Product Change Notification - SYST-23SBVG835

ERRATA - ATtiny417/817 Silicon Errata and Data Sheet Clarification

ATtiny417/817 Silicon Errata and Data Sheet Clarification

3.1 Memories

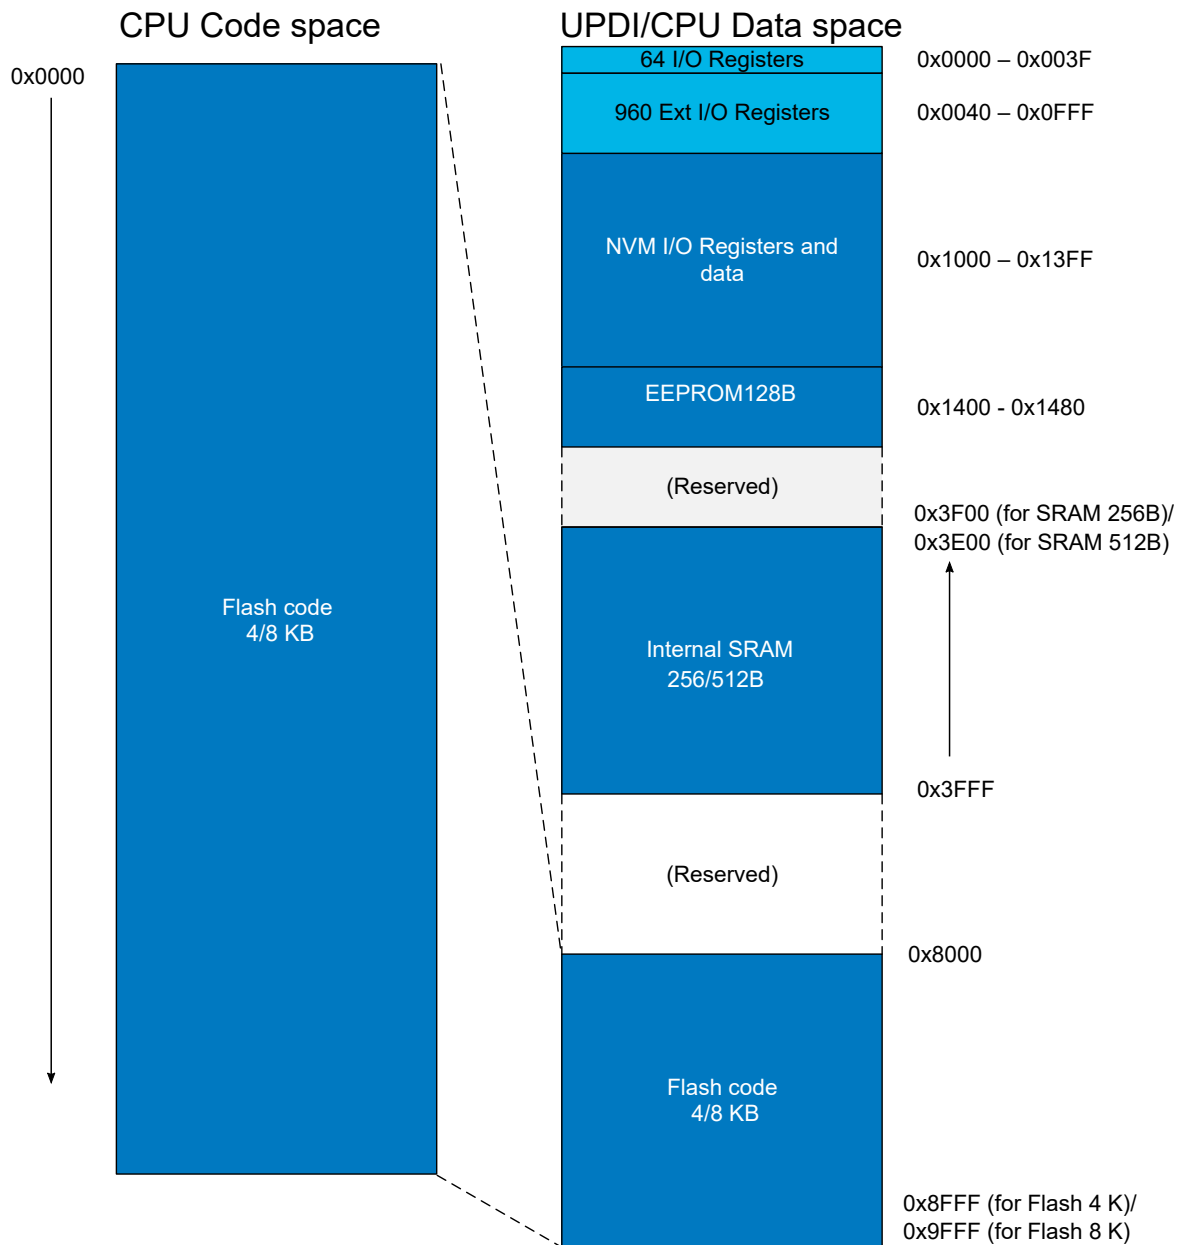
Memory Map is missing from chapter 6.2 in the data sheet.

3.2 ADC

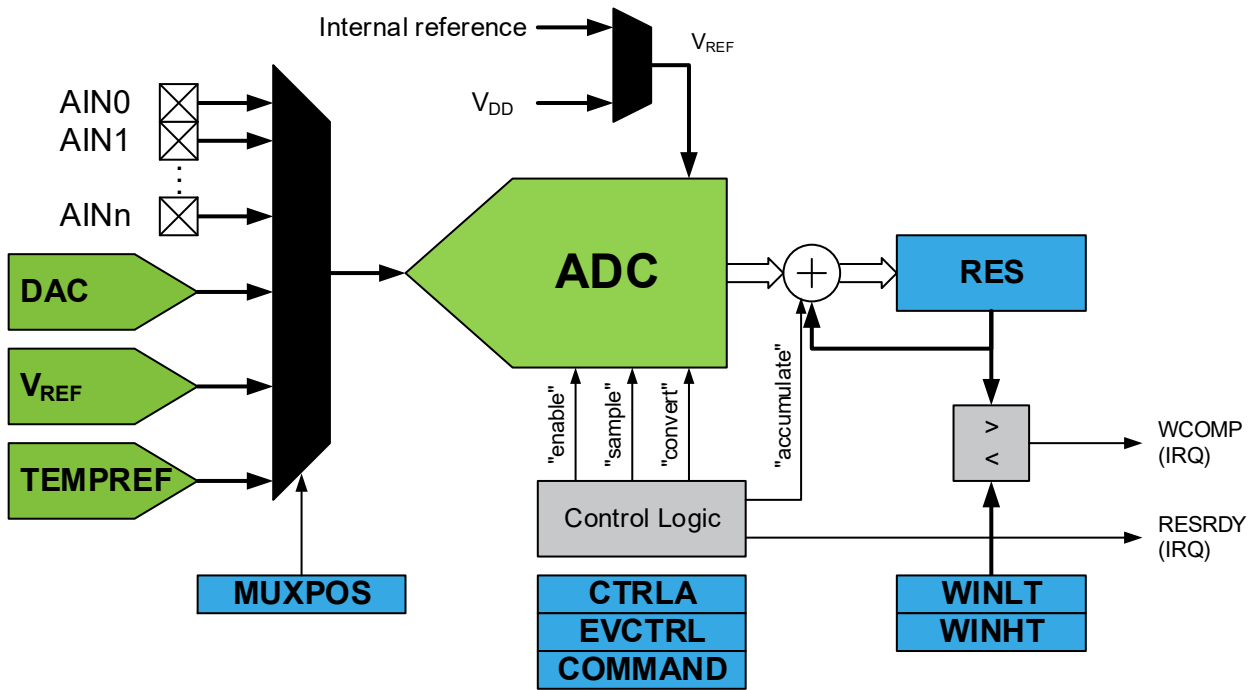
Block Diagram image is missing from figure 30-1 in the data sheet.
